**STAFF REPORT:** 11/10/2021 MEETING  
**APPLICATION NUMBER:** #21-7582, #21-7583  
**ADDRESS:** 9710 & 9730 W OUTER DRIVE  
**HISTORIC DISTRICT:** ROSEDALE PARK  
**APPLICANT:** NICOLE FRICKE  
**PROPERTY OWNER:** REBECCA KENDERES  
**DATE OF PROVISIONALLY COMPLETE APPLICATION:** 10/18/2021  
**DATE OF STAFF SITE VISIT:** 10/22/2021

**PREPARED BY:** D. RIEDEN

**SCOPE:** REHAB OF BUILDINGS, REPLACE WINDOWS, NEW ADA RAMP

Figure 2 by applicant, Scope of Work map showing work items listed for buildings 9710 and 9730 W Outer Dr.

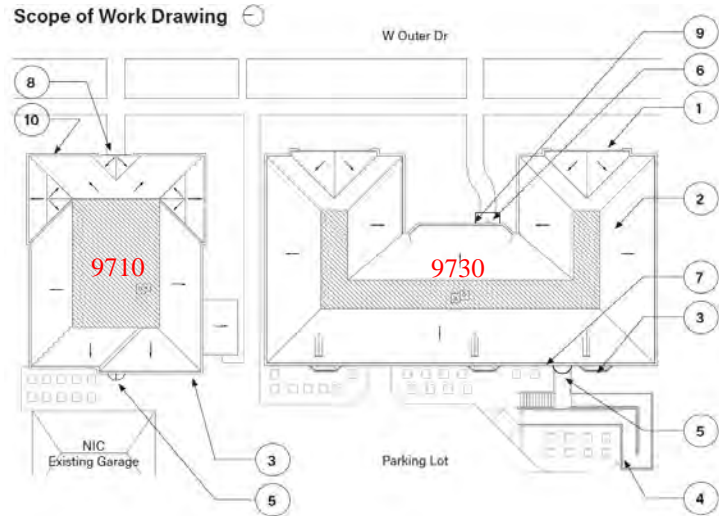
- Staff reviewed the proposed site plan (see fig.2) and the location of the maple tree, which staff verified upon a site visit, appears to be a healthy, 6” caliper red maple. Although just outside of the historic district boundary, staff observed that there are no other trees on this property of this size could be potentially considered a character defining feature of the landscape. Staff also observed that this tree could be retained if one parking space were sacrificed and the curb line adjusted outside of the tree’s dripline or retained at its current location. The proposed ramp does not appear to have impact on this tree’s current location. Staff requested a response from the applicant on the potential adjustment of the site plan to retain this tree and has not yet received a response at the time of this report.

**EXISTING HEAD/MEETING RAIL/SILL**

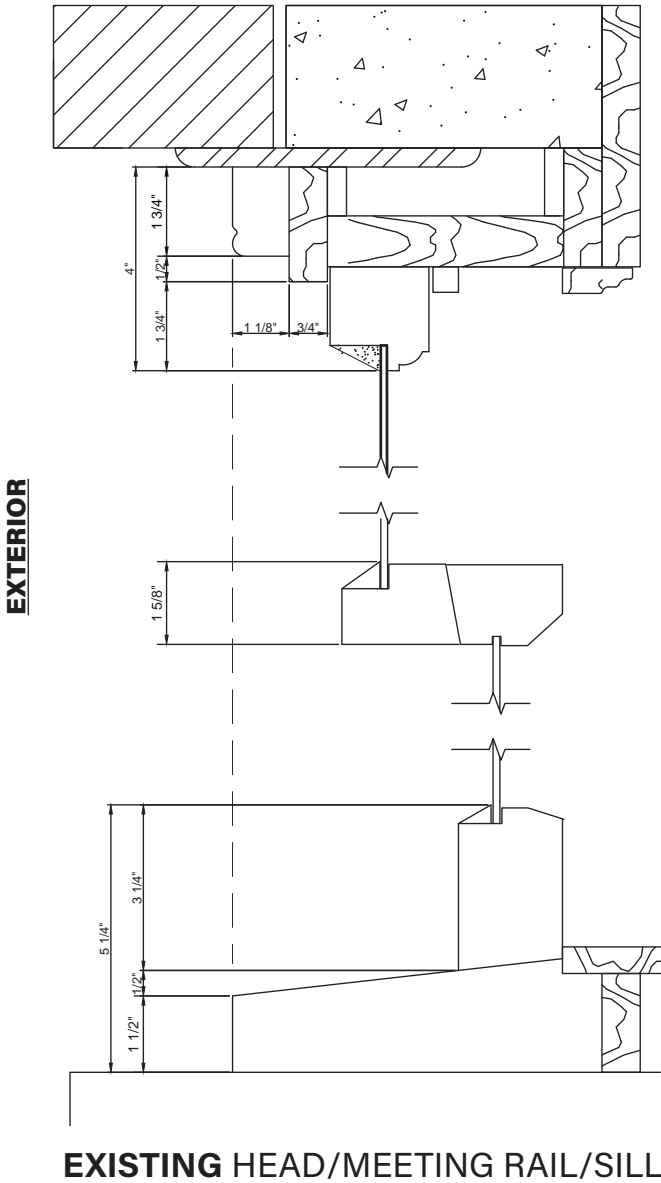
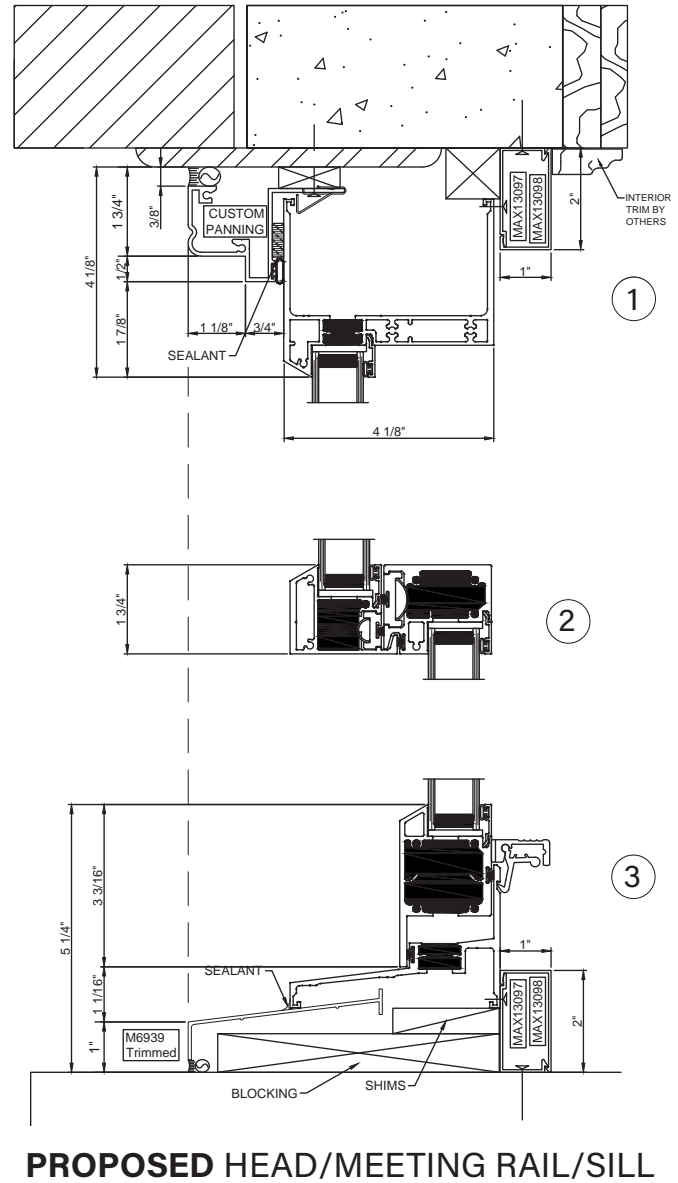
- Please provide an exterior view of the proposed windows, particularly those that match the sill detail on page 13. This can be a catalogue image that matches what is being proposed.

- Questions 3 and 5: the products we're proposing are used regularly for historic projects, and some of the required profiles (brick mould, muntin, mullion, etc), require a proposed custom die. So we're still waiting for a drawing of these custom profiles to be created - I can provide these drawings as soon as they're available. In the meantime I've added exterior views of the base products on pages 13, 14 and 16. Not all sections will not be 1 over 1; they will match the existing muntin patterning shown on the Window Types & Schedules sheet (A4.0.1), p262 of the document. Muntins will be 3-part simulated divided lites (SDL) with an external muntin bar on both the outside and inside of the window

**Demolition Elevation**  
@ New Accessible Entry

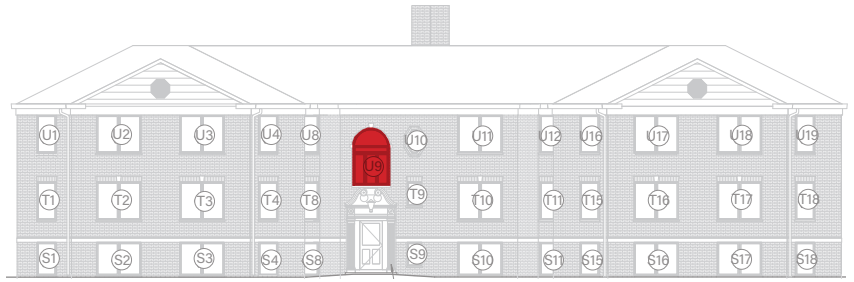
- It is staff’s opinion that the proposed locations of new brick vents are appropriate.
- It is staff’s opinion that there is not enough information to warrant the opening of a new door on the second floor, and the proposed ramp does not meet the NPS Preservation Brief 32 to first consider use of the building’s existing entrances. Therefore, staff finds that this proposed new opening is not appropriate.

Staff finds that the unnecessary addition of a new opening and ramp to the second floor door does not meet the recommendations outlined in NPS Preservation Brief #32 and reduces the historic character of this property.

## New Accessible Ramp

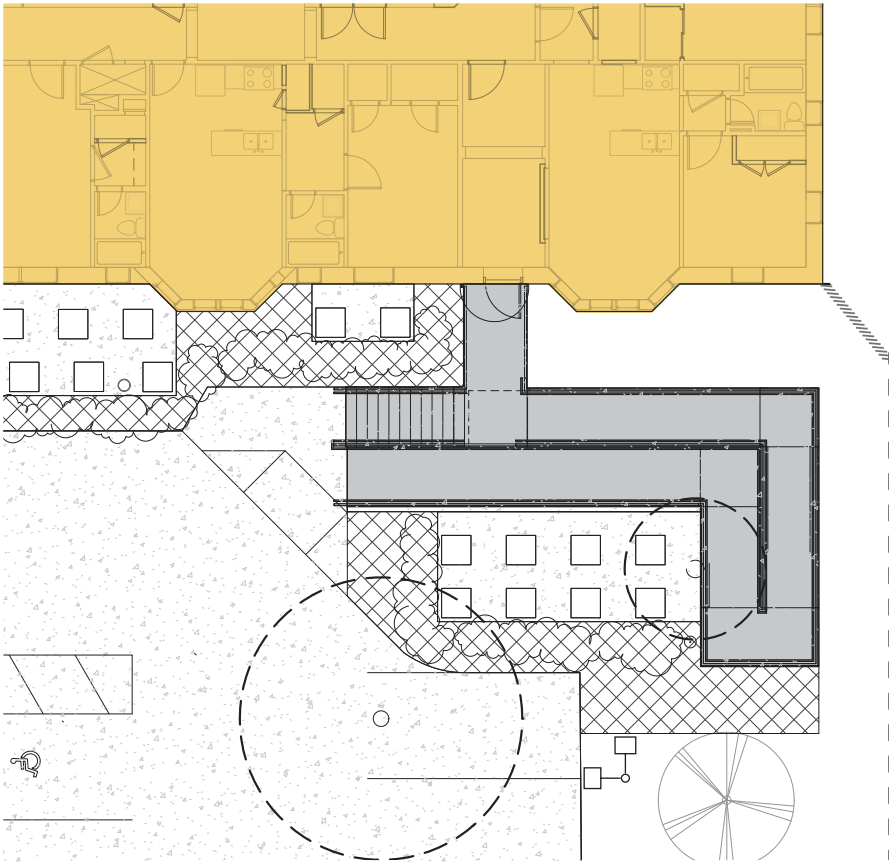
#### Recommendation #1: Rear door opening and ramp:
